**Travel Supreme, Inc.**

06V-152  
(19 pages)

**573 DEFECT & NON COMPLIANCE REPORT**

Description: Mounting nut that attaches brake caliper to the yoke

Keps Nuts and Bolts

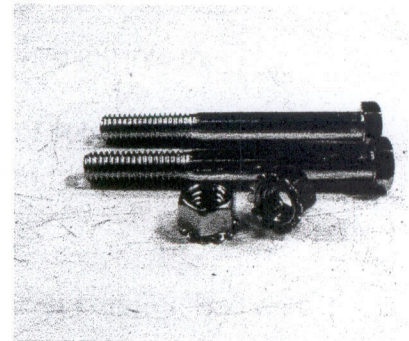
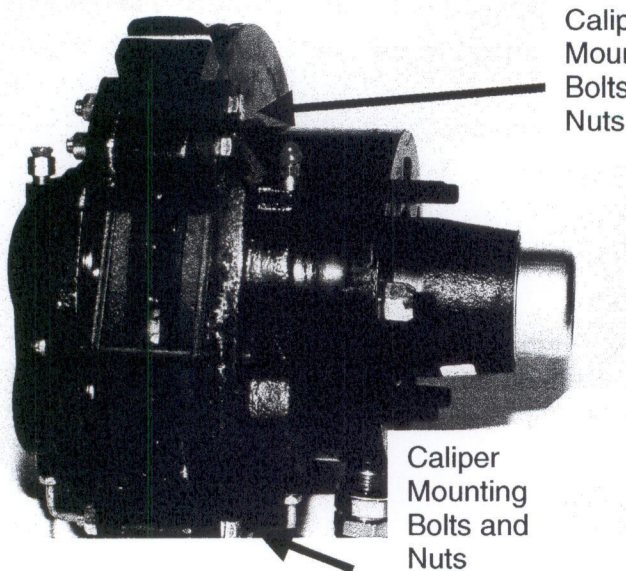
The nature of the defect relates to stripped disc brake mounting hardware. Some of the axles supplied to us from February through March 2006 may have a caliper mounting bolts that are stripped. Insufficient clamp load between caliper and yoke can cause the caliper to disassemble and adversely affect the trailer's braking system.

1. Jack up trailer and secure on adequate capacity jack stands. Follow trailer manufactures recommendations for lifting and supporting the unit.
2. Remove the wheel from the hub, leaving the brake exposed.
3. Make sure hydraulic system is not pressurized during the hardware replacement.
4. Replace the four caliper mounting bolts and nuts with new supplied bolts and "Keps" nuts

**NOTE:** The bleeder fitting must be removed in order to replace one of the bolts. Carefully remove the fitting and cover the hole to prevent dirt from entering. After inserting the new bolt, re-install the bleeder fitting. **The system will not need to be re-bled if care is taken to prevent loss of fluid.** If excessive brake fluid is lost, the system should be re-bled according to the attached instructions.

5. Torque all four Keps nuts to 30 lb ft.
6. Remount the wheel. Start wheel nuts by hand to prevent cross threading.
7. Tighten wheel nuts in a "cross pattern" following the manufacturers recommendations for proper torque setting.
8. Spin wheel to ensure proper clearance between the wheel, crossover brake line and the rotor.
